VENDOR SERVICE PUBLICATION

SUBJECT: Scott Service Bulletin No. 1248H-32-53, Aviation Hydraulic Pressure Unit Left and Right Hand (Master Brake Cylinder)

SERVICE BULLETIN
AVIATION
HYDRAULIC PRESSURE UNIT
LEFT AND RIGHT HAND
(MASTER BRAKE CYLINDER)

PART NUMBER 1248-H LEFT HAND MASTER CYLINDER

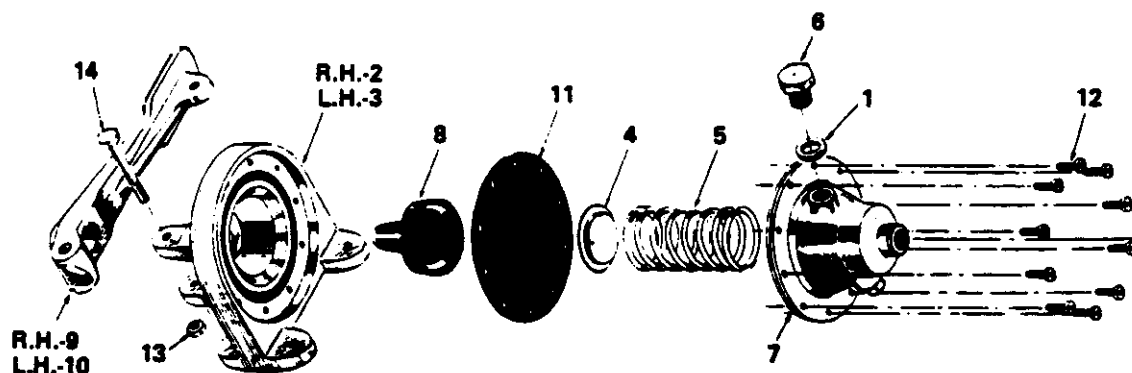
To replace an existing diaphragm suspected to be defective, with replacement diaphragm. An unknown quantity, out of the total number of diaphragms released into our product system, from third quarter 1986 through second quarter 1989, fabricated from an elastomeric material which is not compatible with the required MIL-H-5606 hydraulic fluid. When pressure is applied to the brake the diaphragm could rupture causing a loss of aircraft braking.

Remove and replace diaphragm. Reference Item 11, Page 3 of 3.
